DESIGN REVIEW BOARD – URBAN DESIGN PANEL

February 2nd, 2023

**Planning Staff Report to
Design Review Board - Urban
January 18, 2023
for the February 2, 2023 Public Hearing**

**Planning Staff Report to
Design Review Board - Urban
January 18, 2023
for the February 2, 2023 Public Hearing**

Existing Conditions – Window Locations

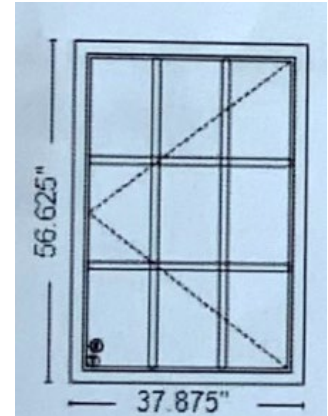
Overall, the proposed windows are very similar in appearance to the existing windows on the structure. The windows proposed close to the corner are each 3 feet wider than the existing windows. Another key difference in the new windows versus the existing windows is the ability to open them since they are casement windows as opposed to the existing fixed windows.

Per PRI 5.1, building corners should be accentuated with architectural features such as enhanced window designs. The window addition and expansion on either side of the northeast corner of the building is in conformance with this guideline.

Staff finds the proposed window replacements and addition to be in compliance with design guidelines. Staff therefore recommends approval with the following conditions:

PRI 3 Entry

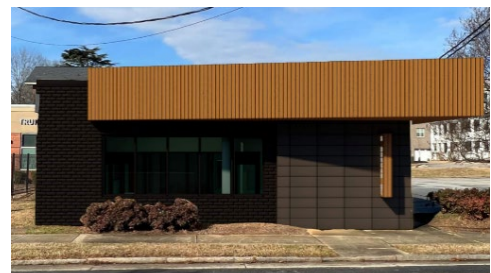
PRI 3.3 suggests enhancement of entry areas with materials, architectural features, and landscape elements so that they are clearly identified and will attract and guide pedestrians. The proposed relocation of the entry is appropriate based on

the natural movement of pedestrian traffic from the parking area to and from the building. The canopy extension, recladding, and material modifications are effective in enhancing the pedestrian experience at the entry. The proposed entry glass appears to be highly transparent, per PRI 3.4 and the entry is recessed per PRI 3.6.

PRI 4. Activated Ground Floor

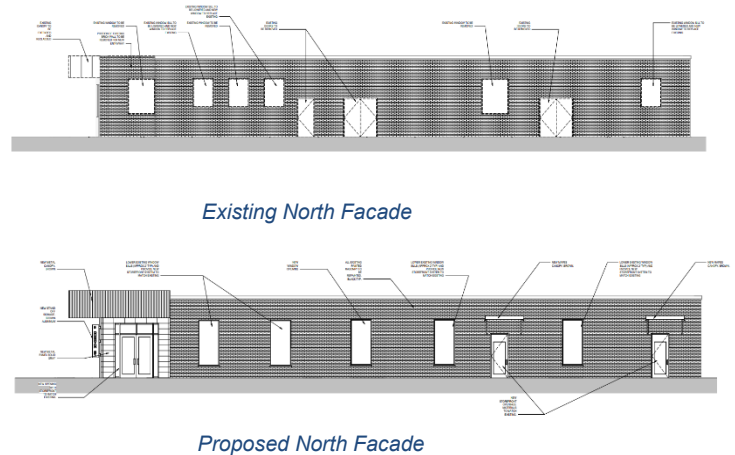
PRI 4.1 recommends maximizing transparency on the ground floor. The proposed lowered sills and reconfiguration of doors and windows on the north façade are in line with this recommendation. The overall transparency will be increased due to these modifications on the north façade. The applicant proposes to reduce the overall transparency on both the west and south elevations by removing and filling in 2 windows. Staff notes that the removal of the 2 windows does not impact the perceived activation of the ground floor due to the locations of the windows away from pedestrian traffic.
